ENGINEERING BULLETIN

Ref Document No.	EB15005	Issue No.	2
Subject	Re-Orientation/modification of MONEx Exhaust back pressure sensor		
Release Date	16 th April 2015		
Client	COALTRAM® Owners / Operators		
Facilitator	PPK

Image 1.

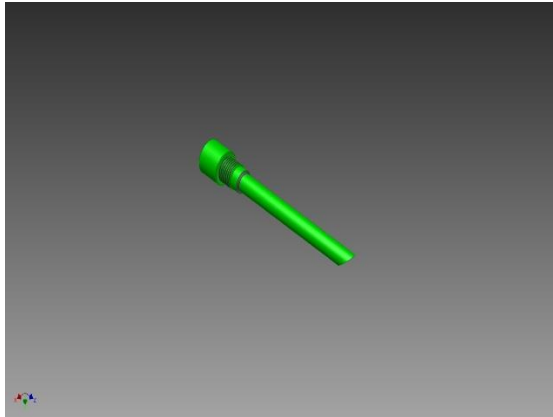
A back pressure sensor extension was designed (part No. 5520009545). This relocates the back pressure sensor higher in a downward orientation, eliminating the trapping of Diesel particulate debris.

The following images show; Image 1. Back pressure sensor extension component. Image 2. Cross section of the back pressure sensor reorientation and fitment. Image 3. Expanded view of the Exhaust back pressure sensor, Sensor extension and scrubber weldment. Image 4. Installed sensor extension and sensor.
